## 9 Site Water Management and Treatment

**Table 9-1 Site Water Management Table of Conformance**

Wolverine Project EAR Response to Public and Regulatory Reviews  
Section 9: Site Water Management and Treatment

**Figure 9-3 Wolverine Project Water Balance Schematic for Operations**

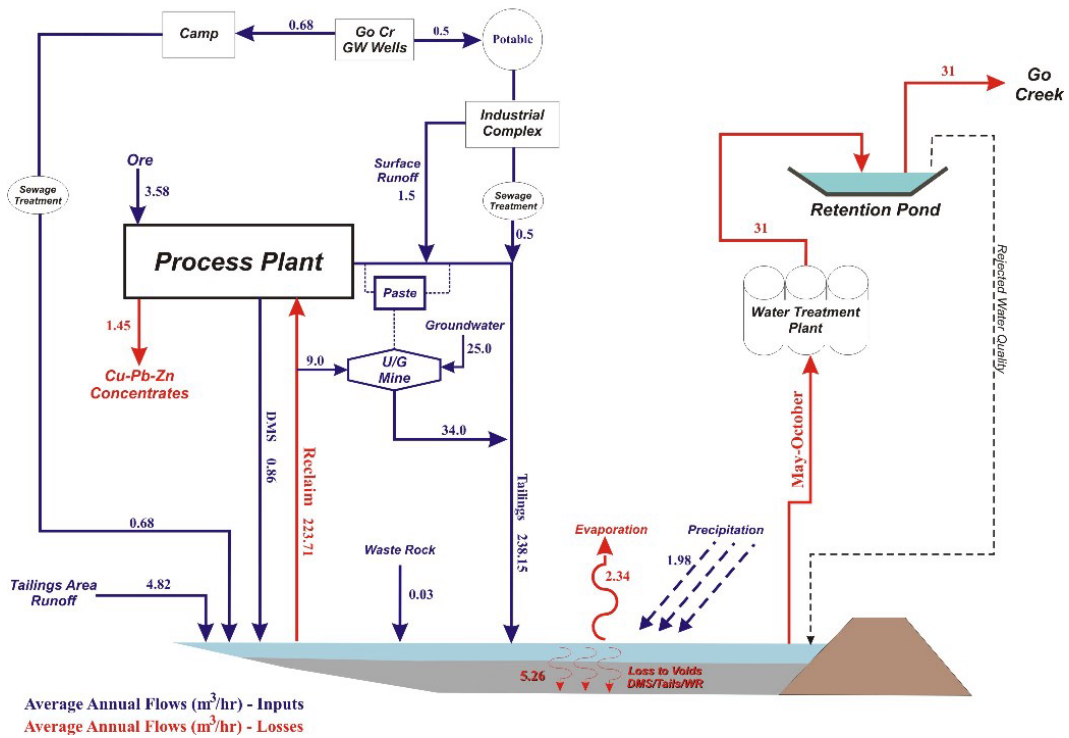
Reviewer	EAR Section	Reviewer Comment	Response Report Section Where Addressed
YTG - Environment Yukon	Section 3.4.1	<b>Mitigation – Predicted Damage</b> Environment and/or social and economic conditions - include a description of commitments, approaches and specific options for restoration, replacement and/or compensation for any potential/predicted damage.	EAR Section 9
YTG - Environment Yukon	Section 2.9	<b>Cumulative Environmental Effects</b> Water quality emanating from the underground has not been “quantified” for the mine at closure.	Sections 6.3 and 6.4
SRK Consulting	Section 3.2	<b>Water Balance - Sensitivity</b> The site water balance was not provided in the EAR. The water balance for a dry and wet year should also be calculated to ensure that appropriate design criteria are used for the engineered structures.	Sections 9.3, 7.6, and Appendix F3
SRK Consulting	Section 2.9	<b>Inputs to Water Treatment Plant</b> Runoff from the industrial complex area, the dirty water storage pond and the temporary waste rock storage pad is to be directed to the water treatment plant. However, this input to the water treatment plant is not shown in the diagram of the water balance.	Section 9.3

Compared to the amount of water being recycled, the input and output of water in the site water balance are relatively small. On a monthly basis, a slight positive water balance exists (Figure 9-4). Over the course of an average year, approximately 136,000 m<sup>3</sup> of excess water accumulates in the tailings facility. The treated water discharge of 31 m<sup>3</sup>/h is designed to treat and discharge that volume of excess water over a six-month period, corresponding to the periods of highest flow in Go Creek.
